1
2 **DOCUMENT 00 91 13**
3

8 ADDENDUM NO.1 Date: 08.02.21
9

10 RE: SAUK COUNTY COURTHOUSE AND HUMAN SERVICES BUILDING RENOVATIONS
11 515 OAK STREET, BARABOO, WI 53913 and
12 425 6TH STREET, REEDSBURG, WI 53959
13

2 FIRST FLOOR DEMOLITION PLAN - POWER/SYSTEMS
SCALE: 1/4" = 1'-0"

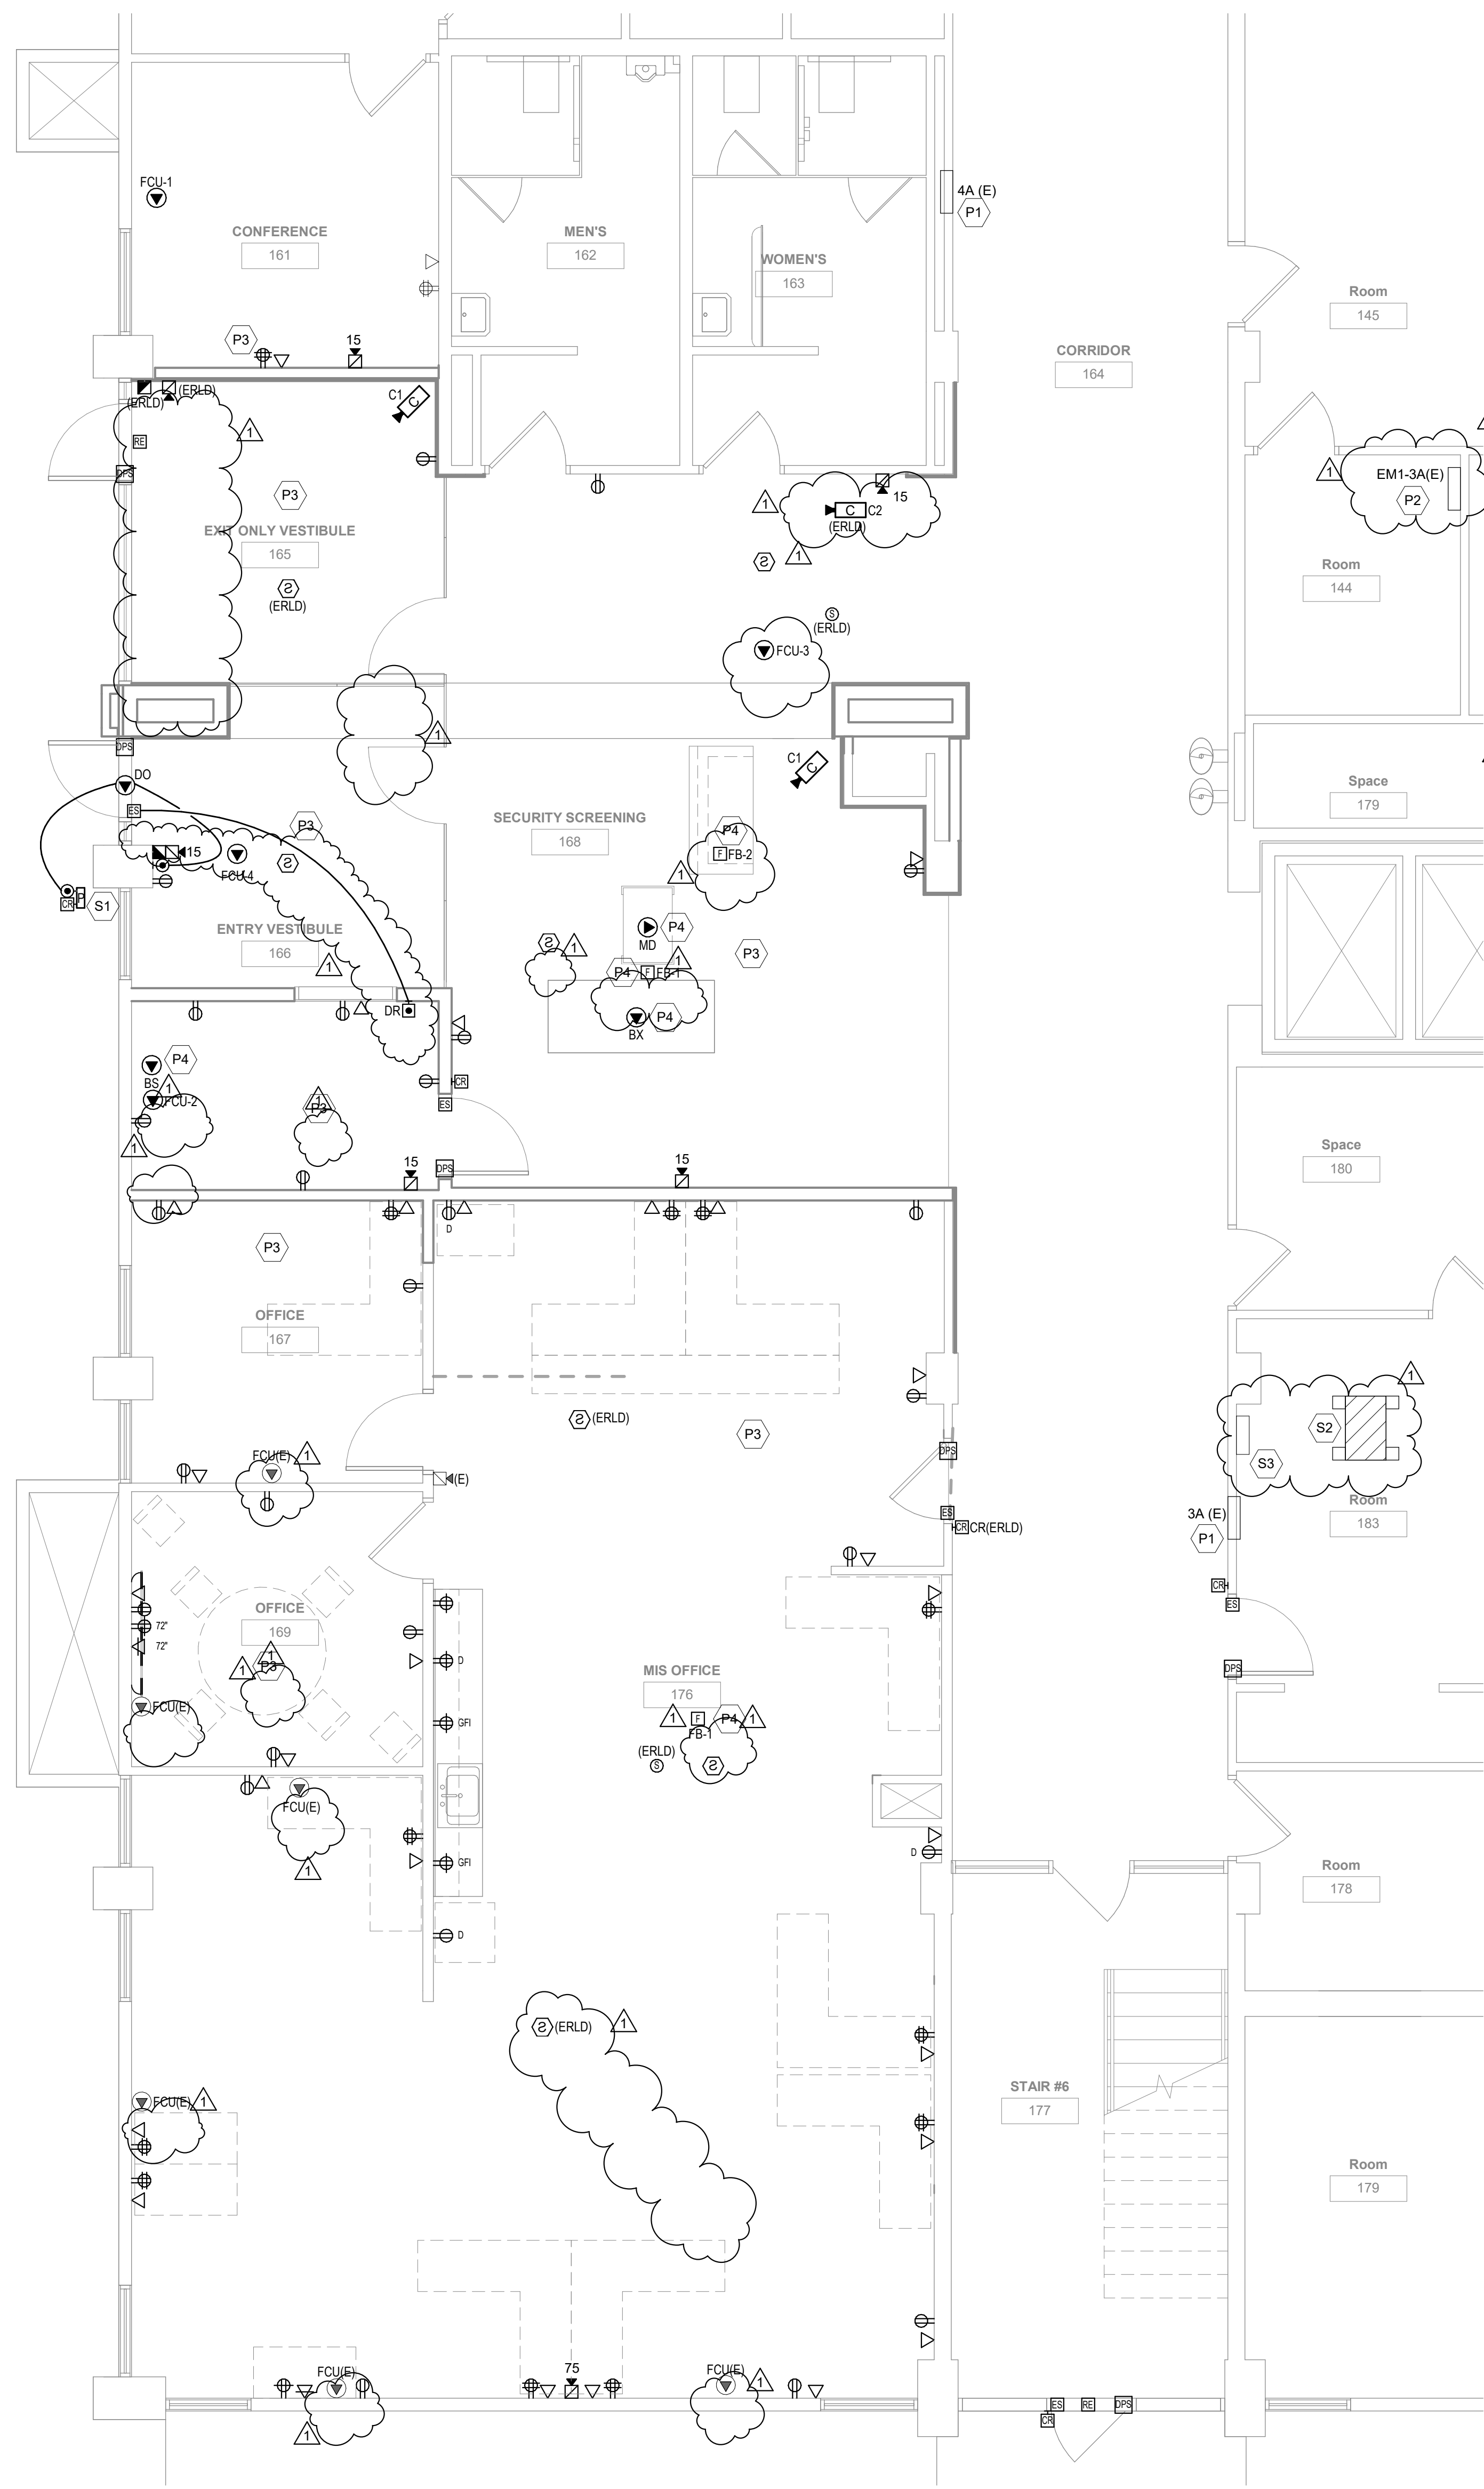
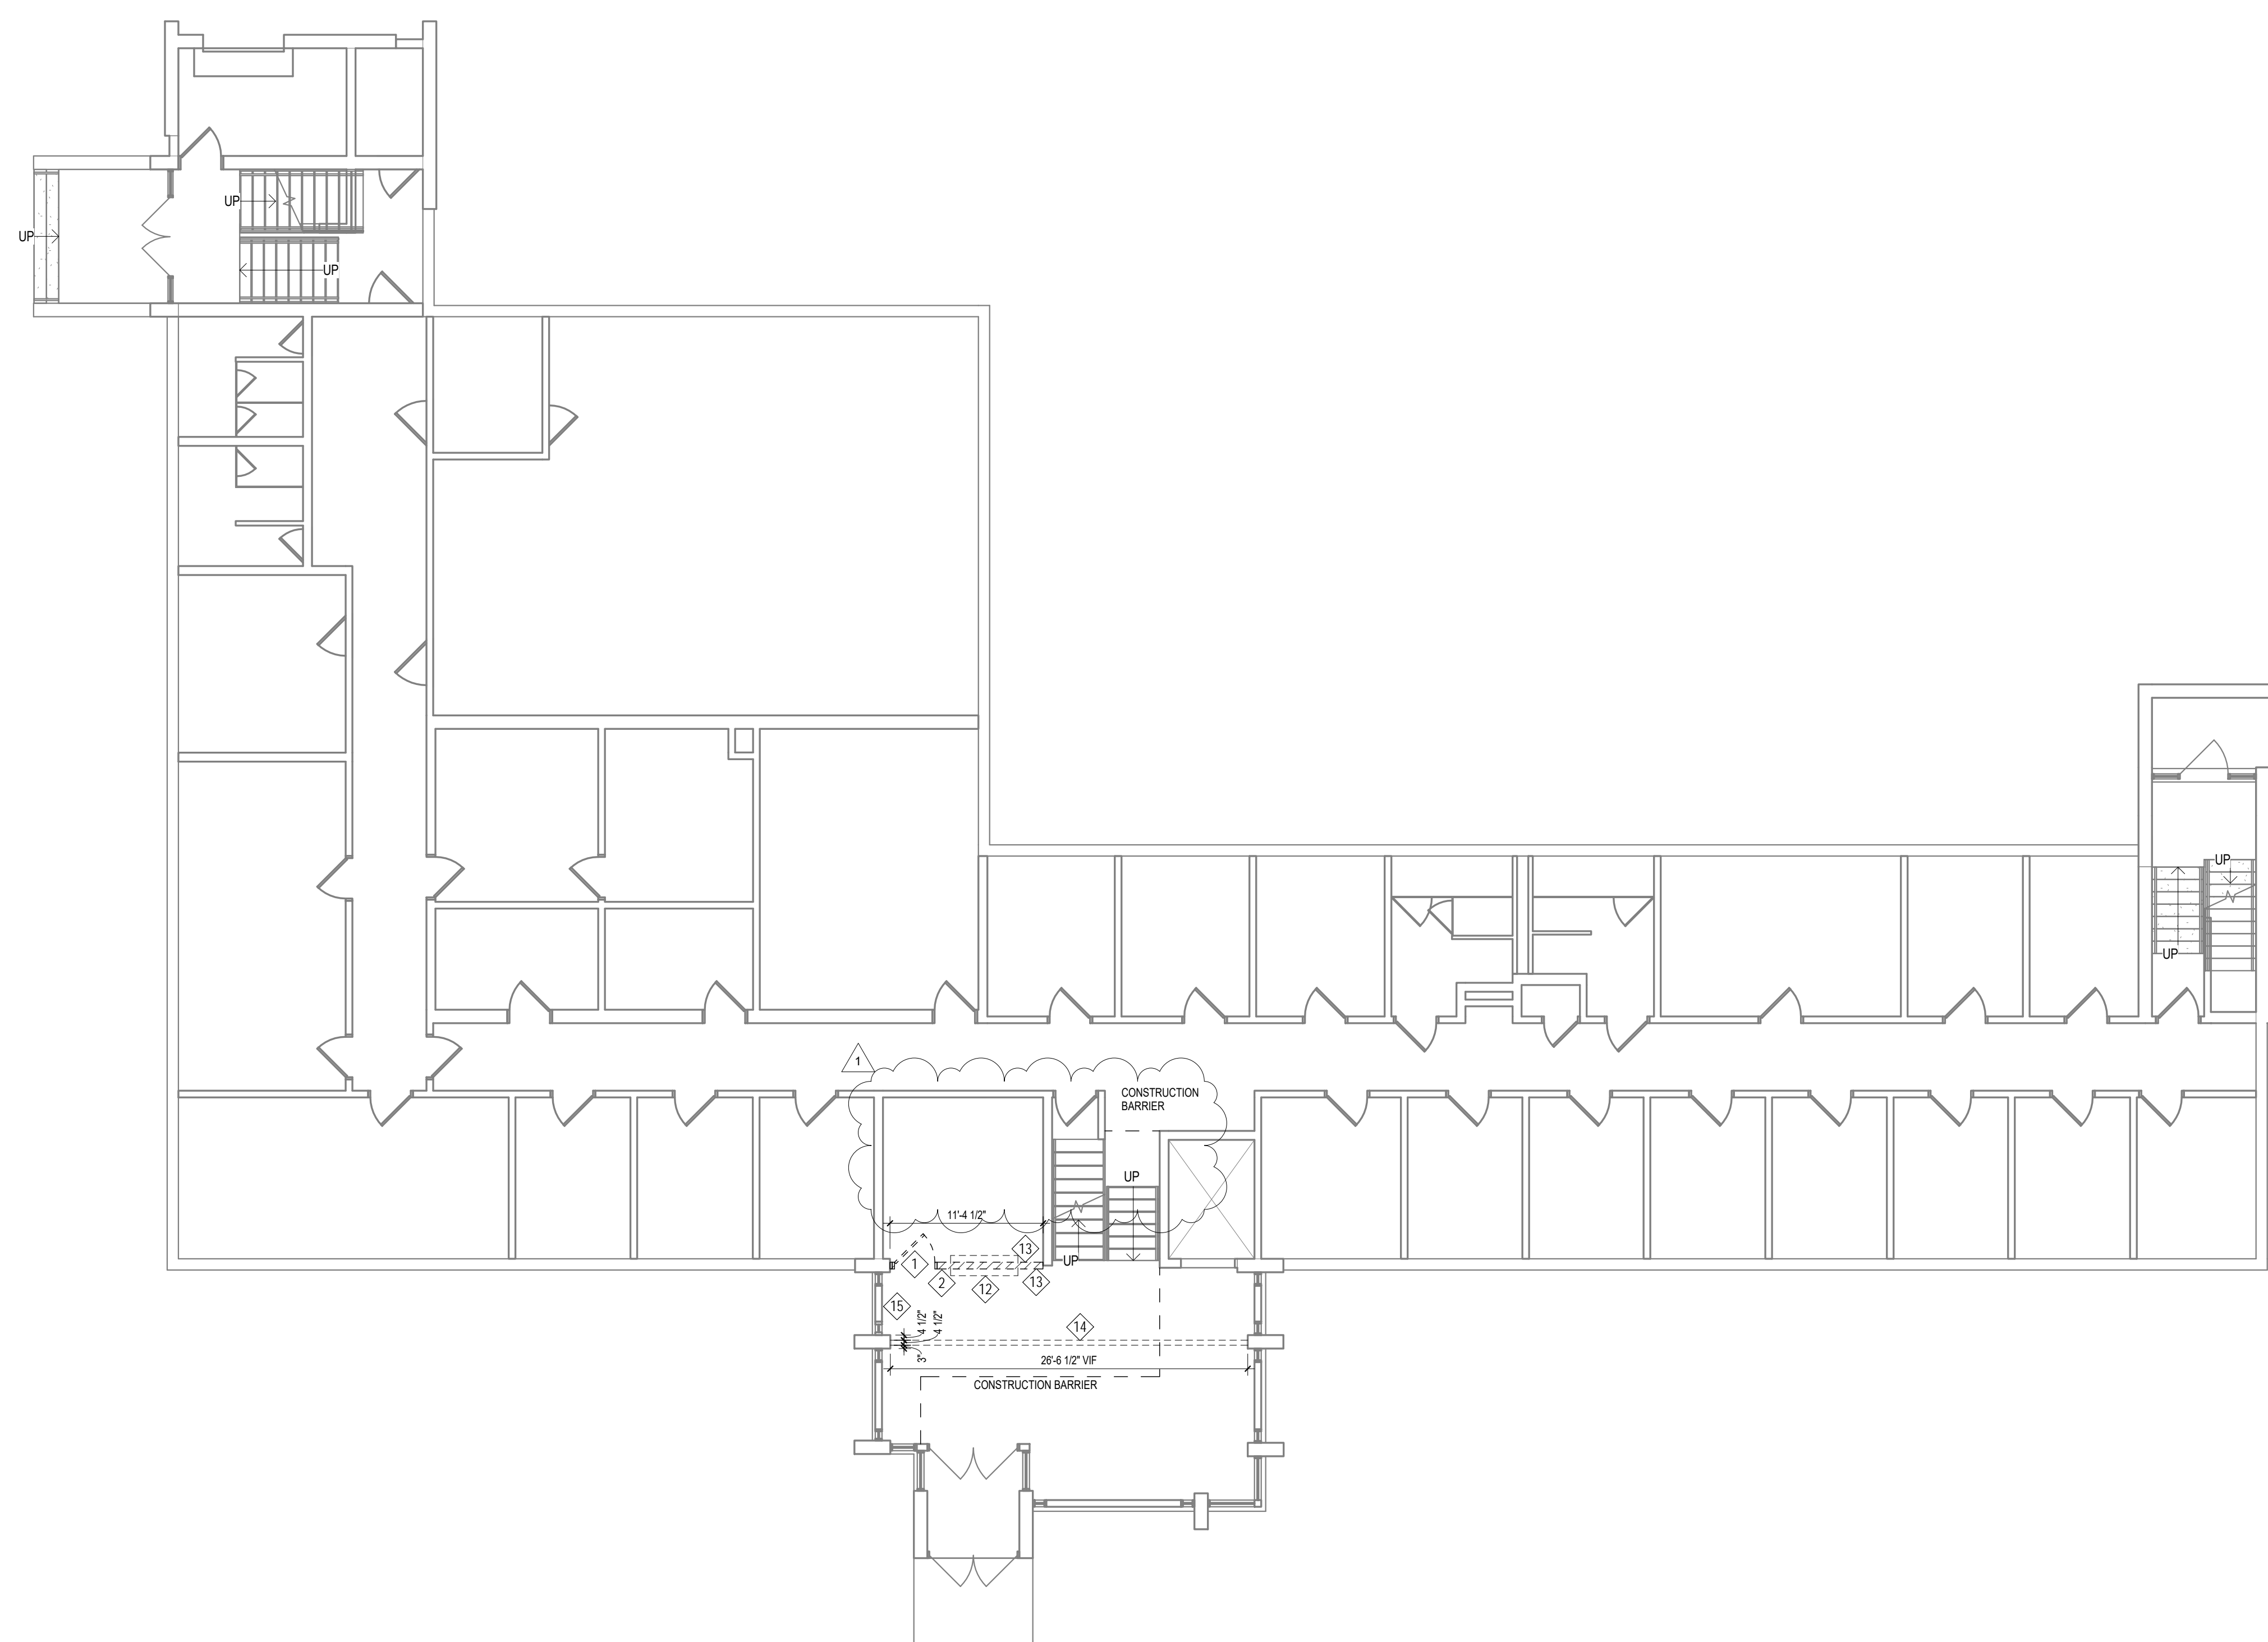
- 1 10. SHEET E102.1, FIRST FLOOR PLANS – POWER & SYSTEMS
- 2 a. Replace sheet E102.1 in its entirety with attached E102.1.
- 3 b. Revised General and Keyed Notes.

1 LOWER LEVEL DEMOLITION FLOOR PLAN
1/8" = 1'-0"

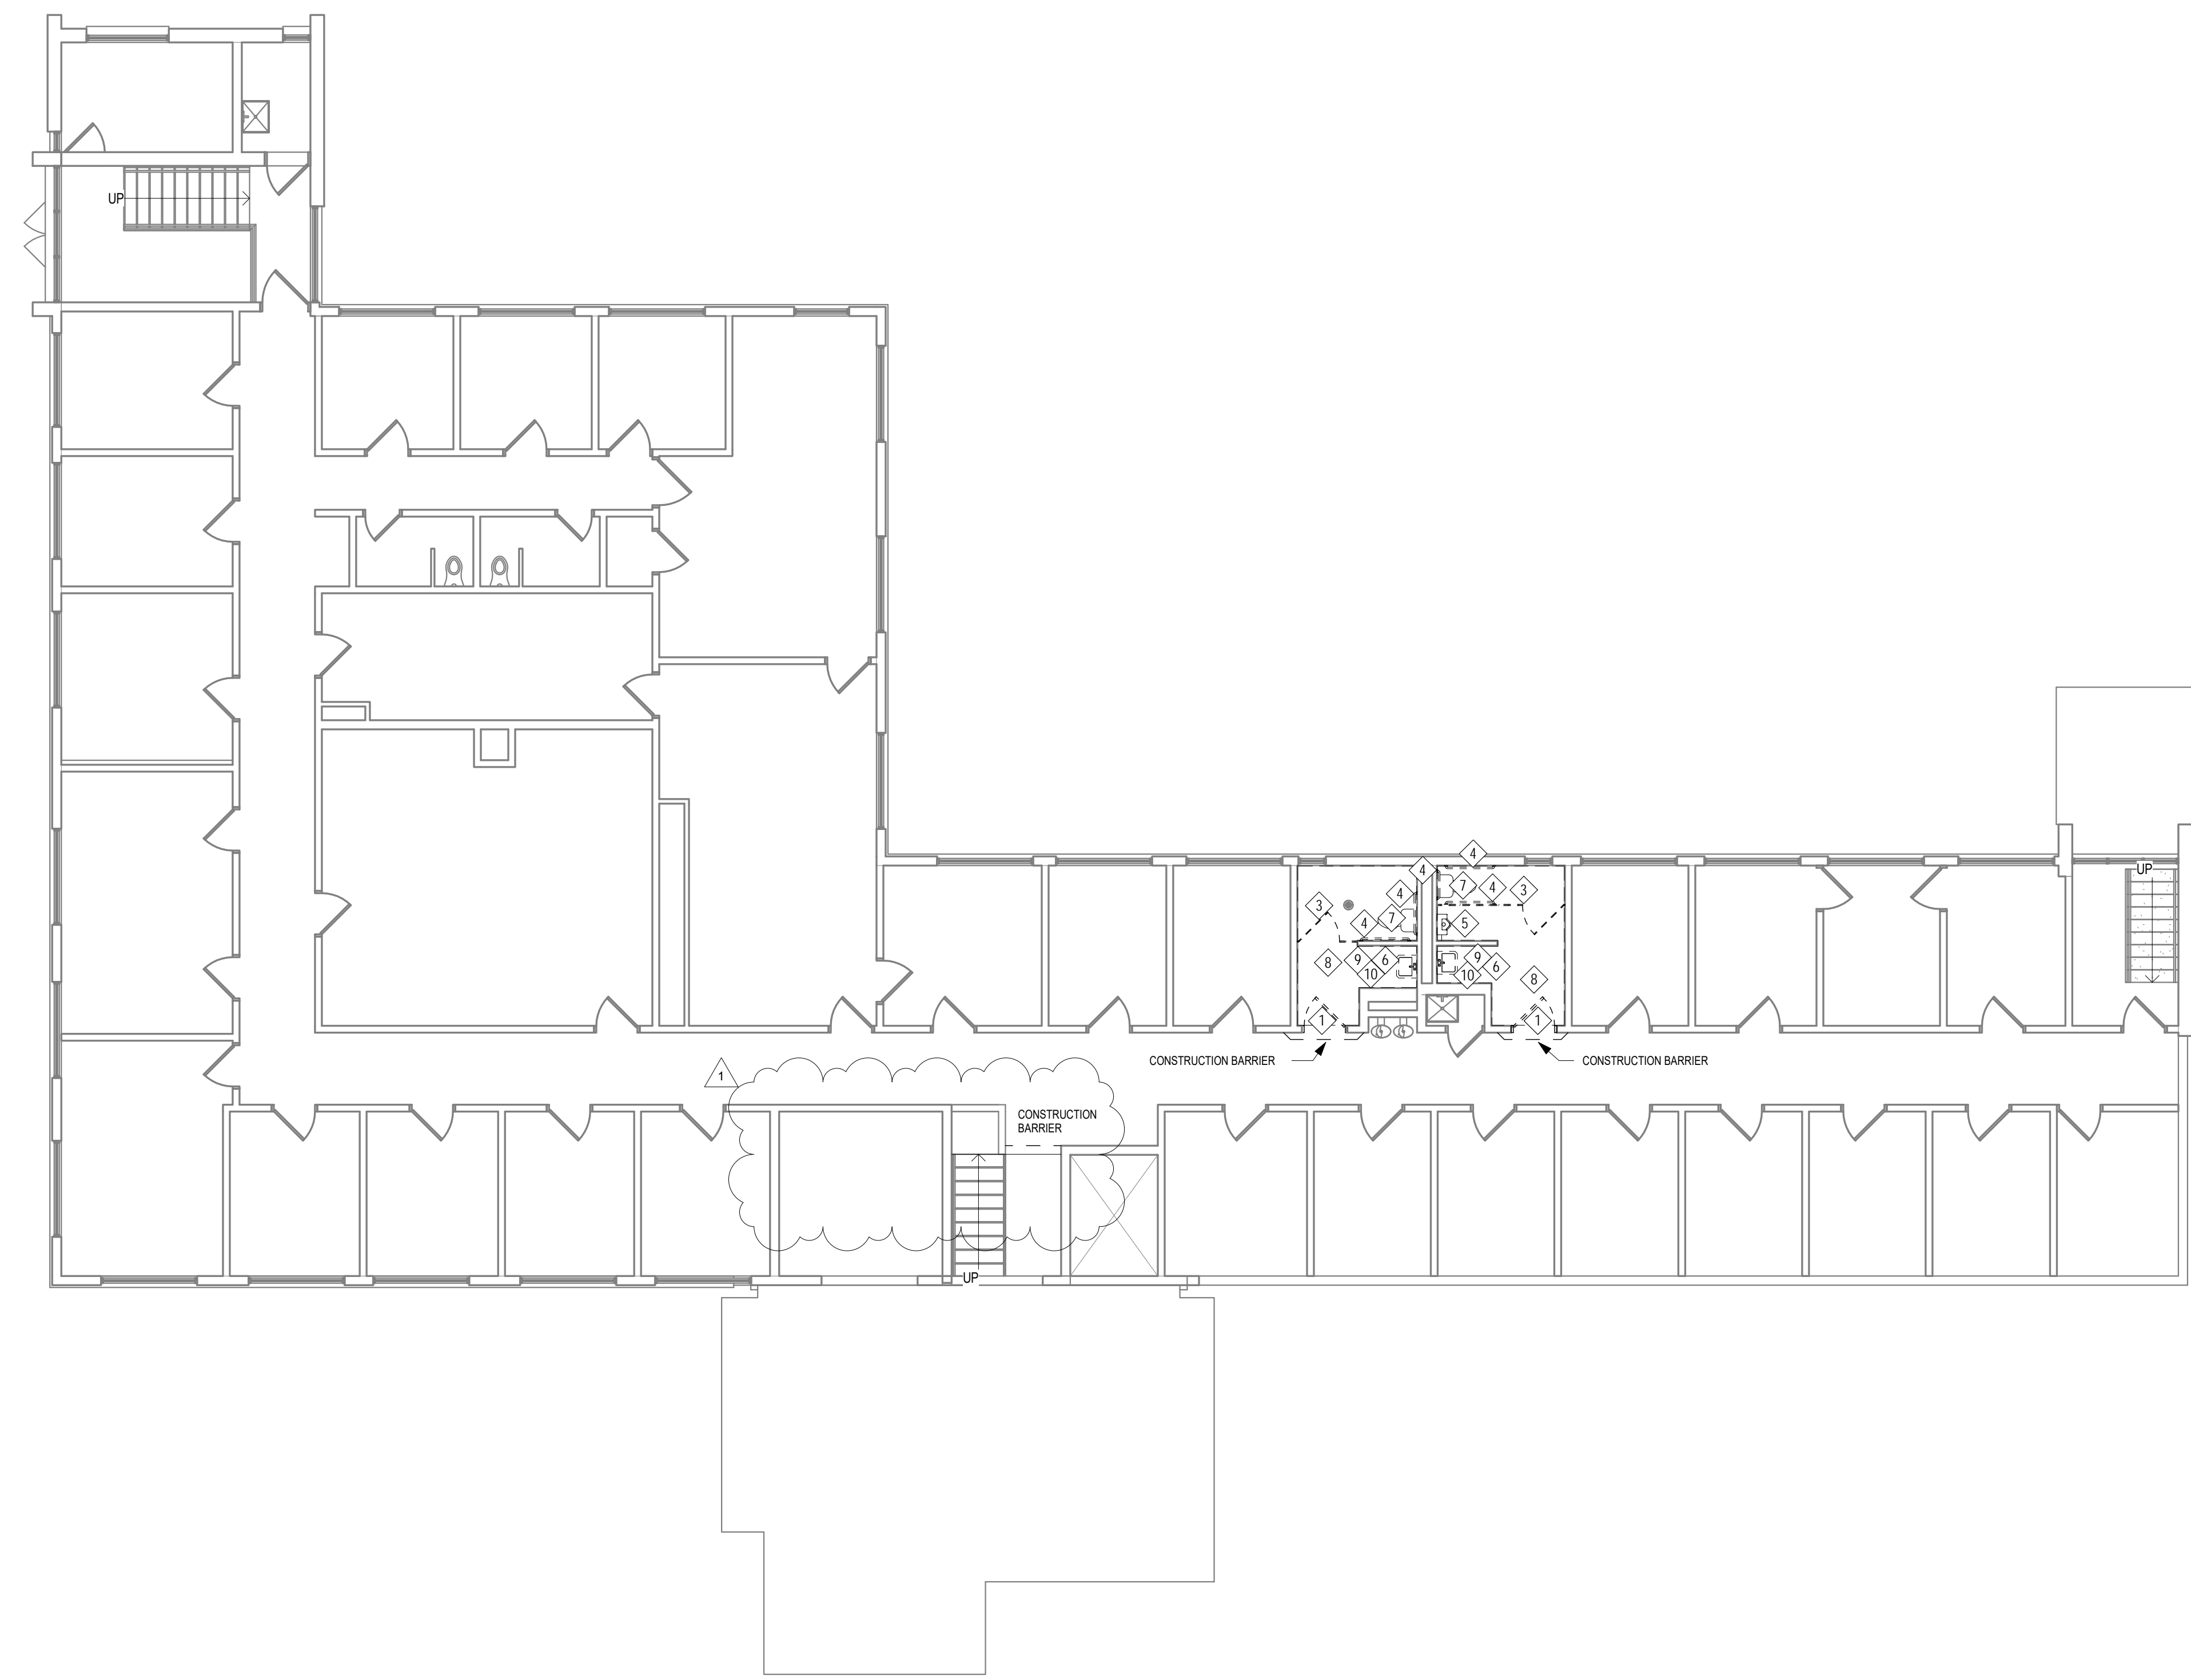
- 4
- 5 11. SHEET D200.2, LOWER LEVEL DEMOLITION FLOOR PLAN
- 6 a. Replace sheet D200.2 in its entirety with attached D200.2.
- 7 b. Revised Office G03 to reflect existing conditions.
